DESCRIPTIVE REPORT

General Locality Providence River

Sublocality Pomham Rocks to Fox Point

H-10772

AWOIS 9938

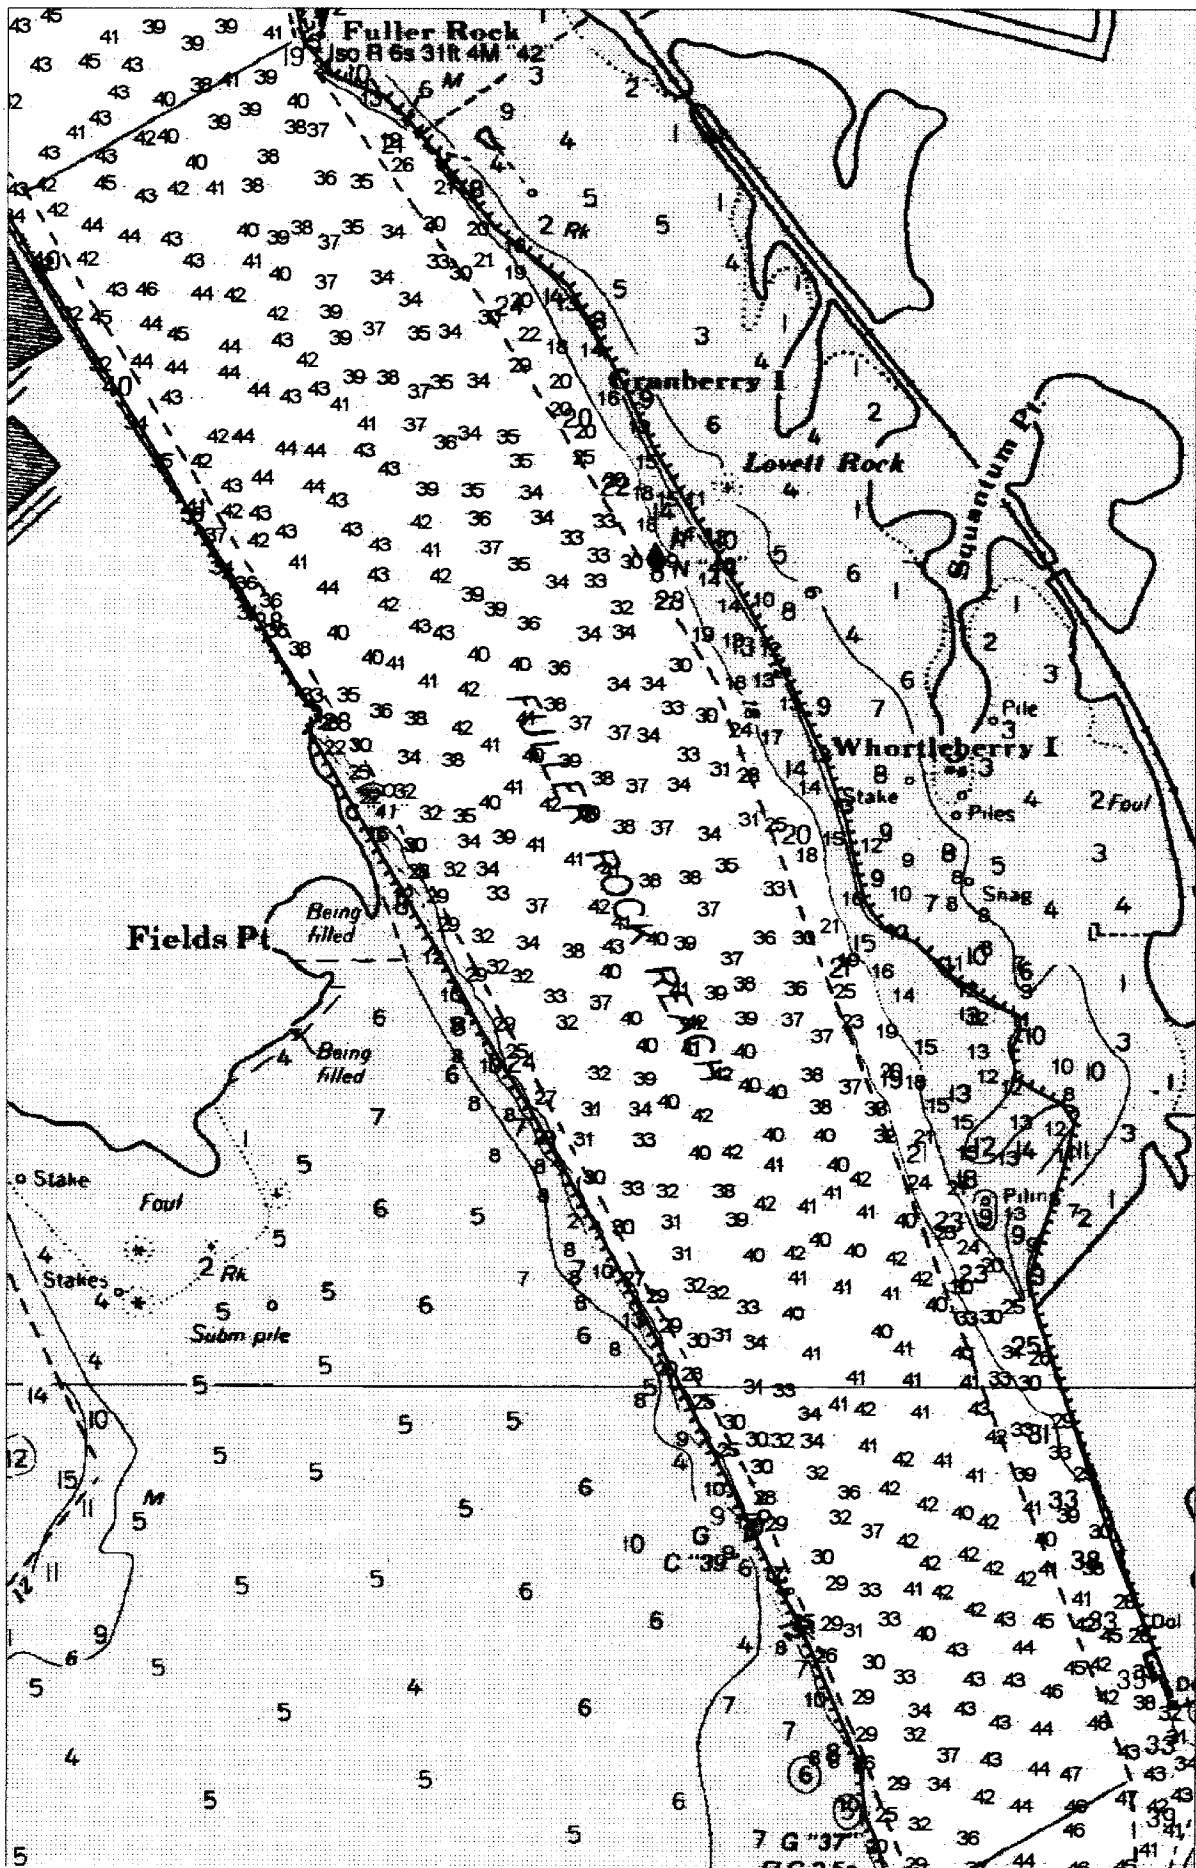
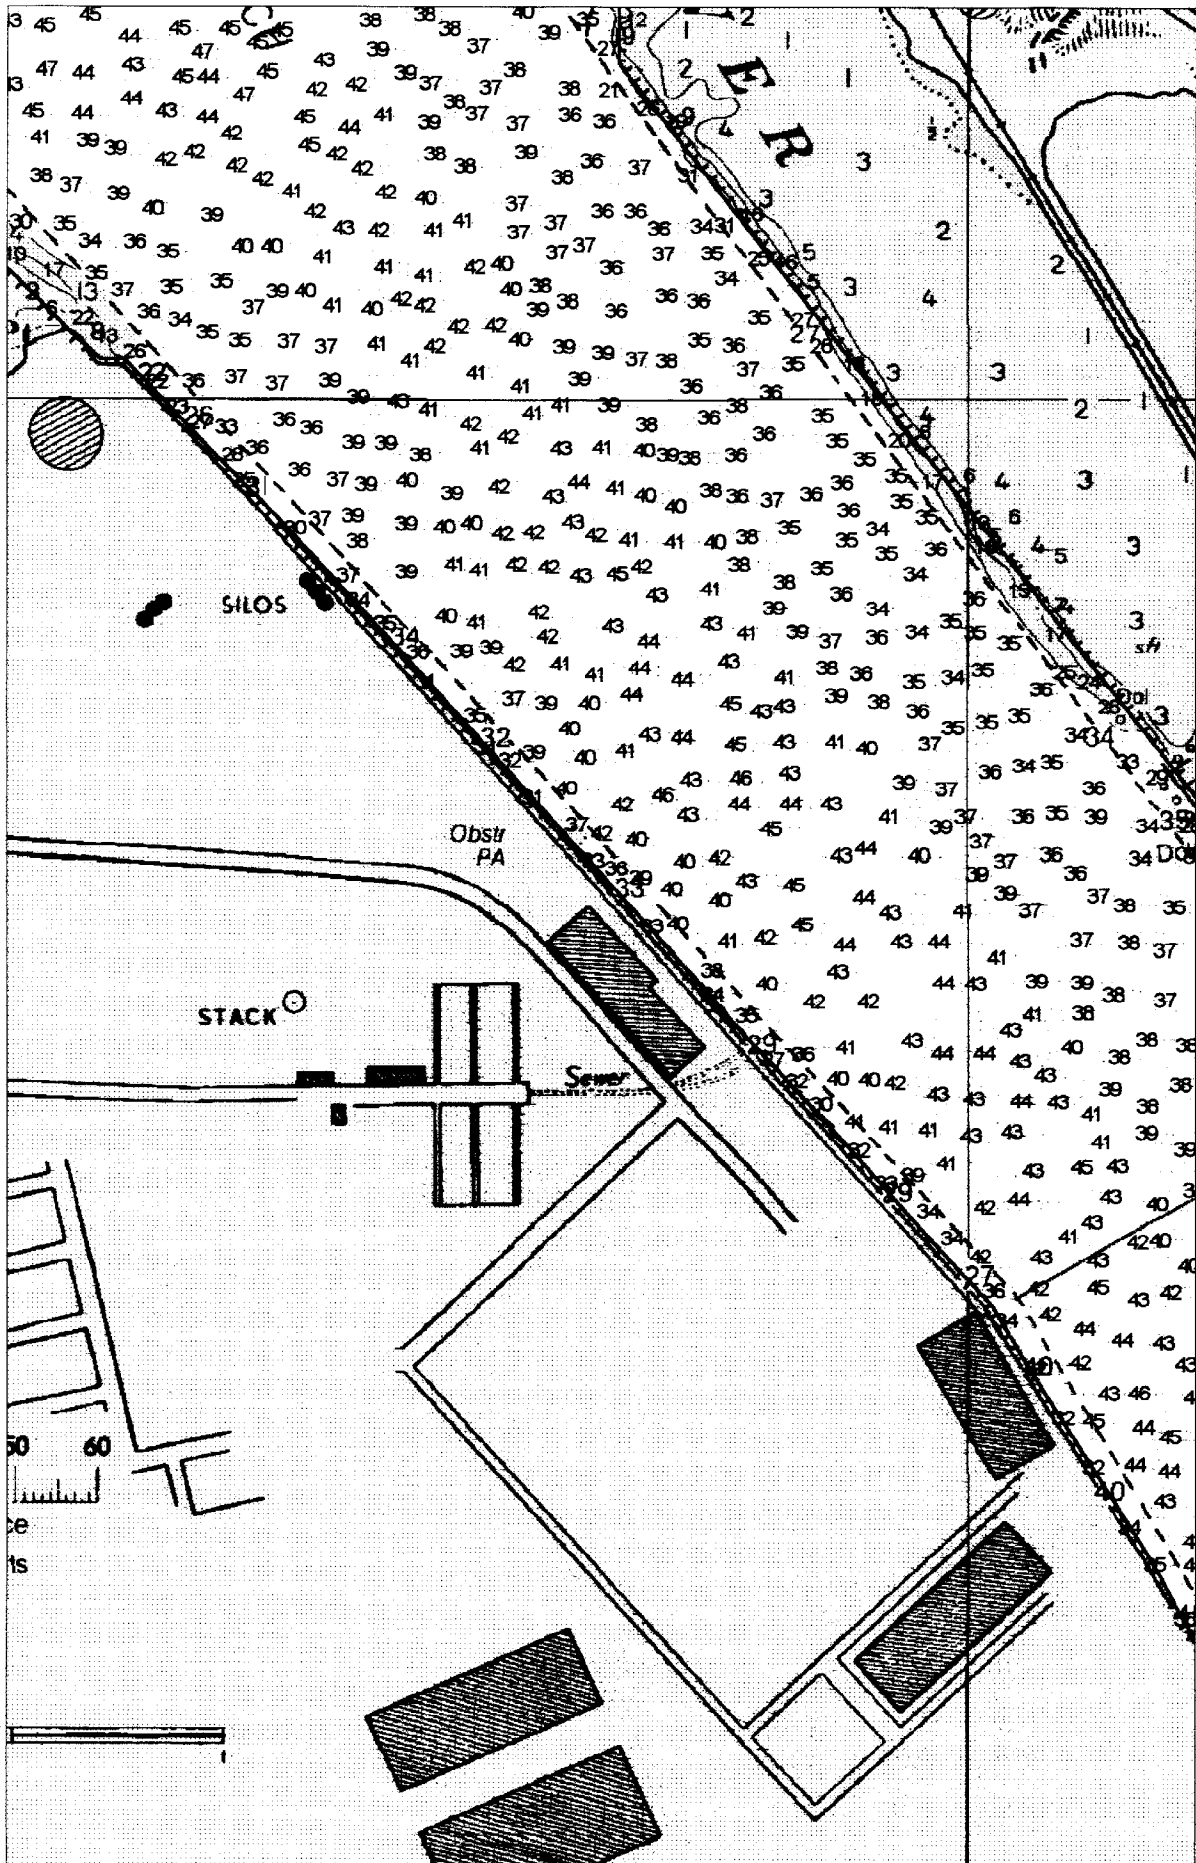
Investigation Summary: Two-hundred percent side scan sonar coverage was performed in the area of the charted obstruction and no significant contacts were found. The area is adjacent to a concrete bulkhead. A discussion with Captain Bruce Fisher of the Northeast Marine Pilots (401-847-9050) indicated no local knowledge of this feature.

The hydrographer recommends removing the obstruction from the chart. *Concur*

DELETE OBSTN FA !!

AWO15 9939

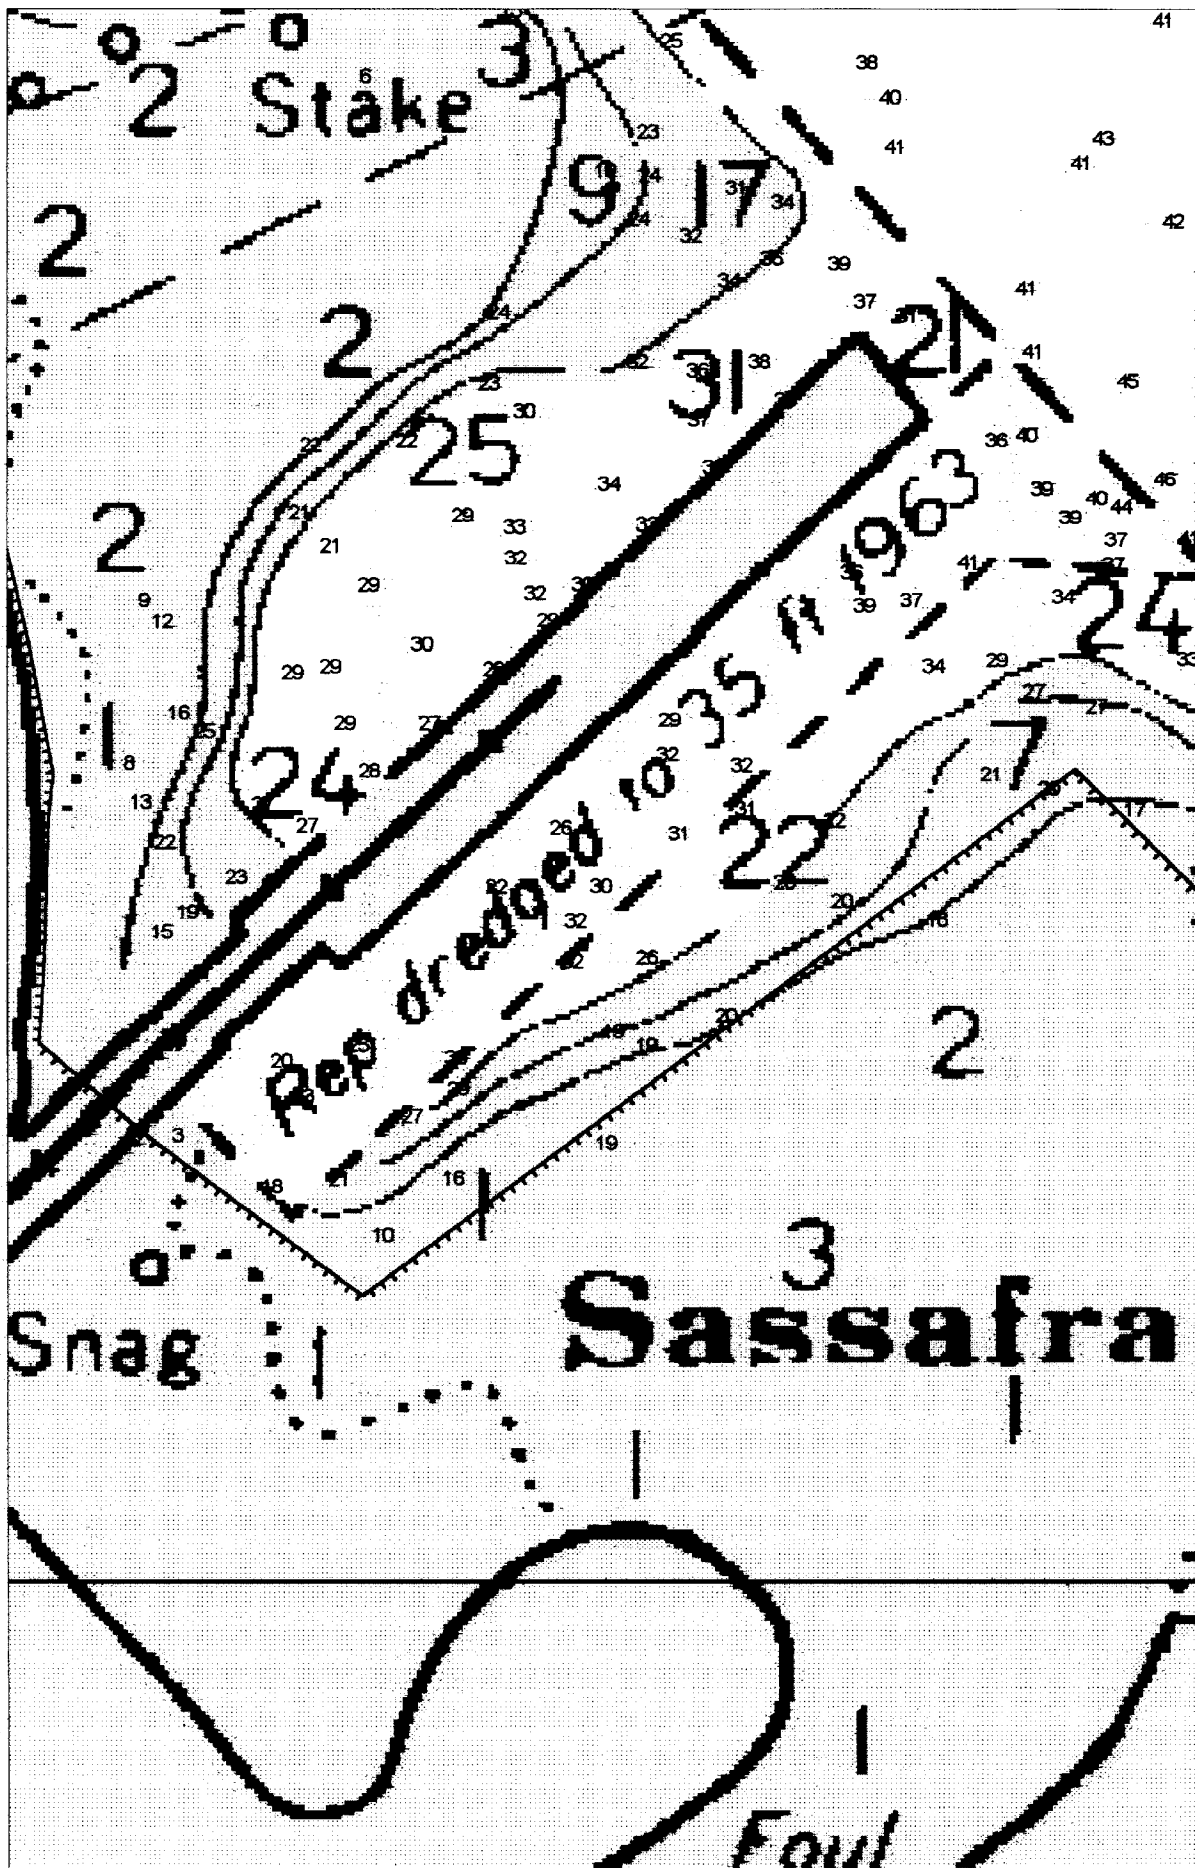
Investigation Summary: Two-hundred percent side scan sonar coverage as well as single beam hydrography at 10-meter line spacing was conducted on both sides of the Texaco fuel pier. Least depths on the east side of the pier range from 36 ft (11m) at the offshore end and gradually rise to 28 ft (8.5m) at the inshore end of the main pier. Least depths on the west side vary from 28-32 ft (8.5m - 9.7m) on the pier face to 21-23 ft (6.4m - 7.0m) at the edge of the slip. ^{15-35'}

The hydrographer recommends removing the "Rep dredged to 35 ft 1963" note and charting current survey soundings in the area. *Concur.*

AWOIS 9940

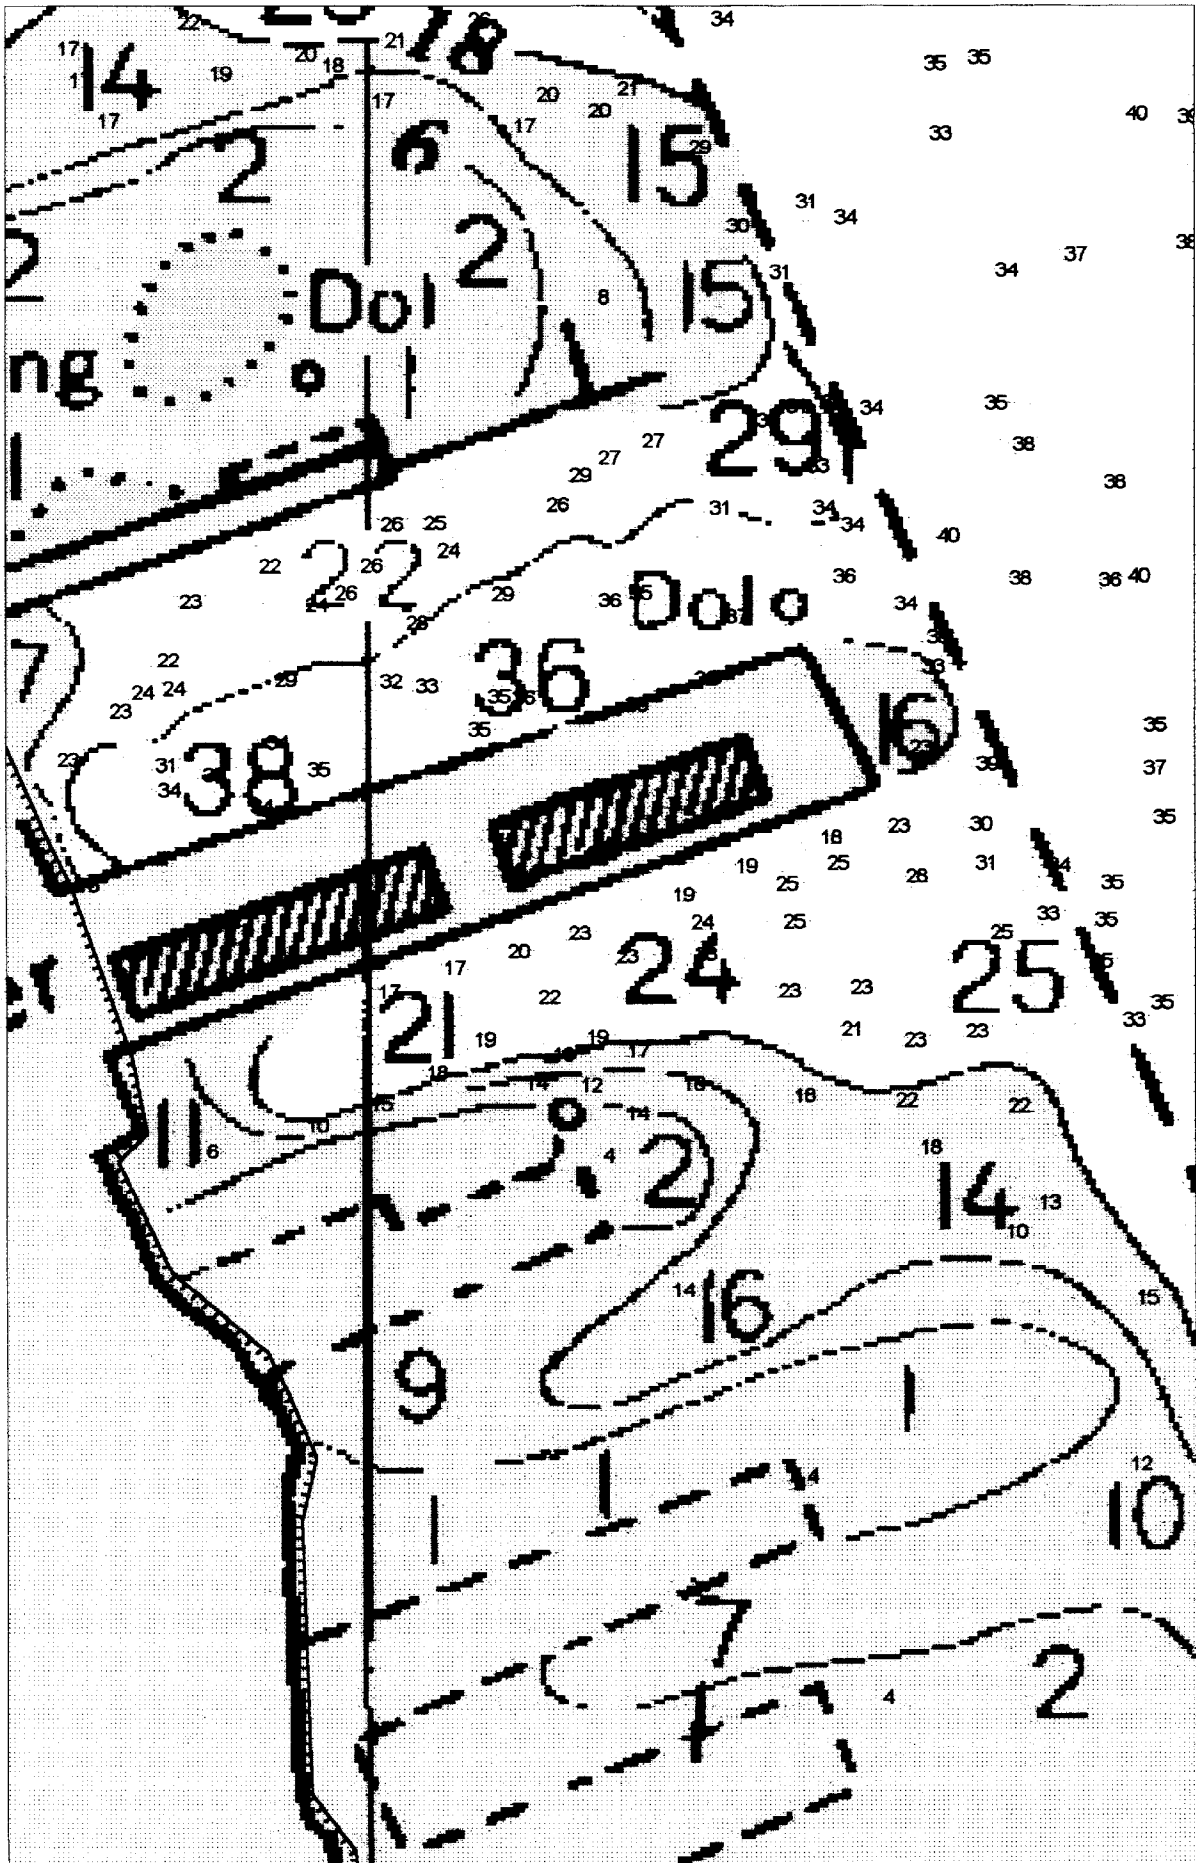
Investigation Summary: Two-hundred percent side scan sonar coverage as well as single beam hydrography at 10-meter line spacing was conducted over the area of the charted dolphin and nothing was found. A telephone discussion with Mr. David Cohen of Promet Marine (401-467-3730), the owner of the pier since 1975, indicated no local knowledge of the dolphin. Mr. Cohen stated that the area has been dredged within the past 2 years. The bulkhead in the area of the charted dolphin is used to moor 60-90 foot fishing vessels.

The hydrographer recommends removing the dolphin from the chart. *CONCUR*

DELETE DOL 0
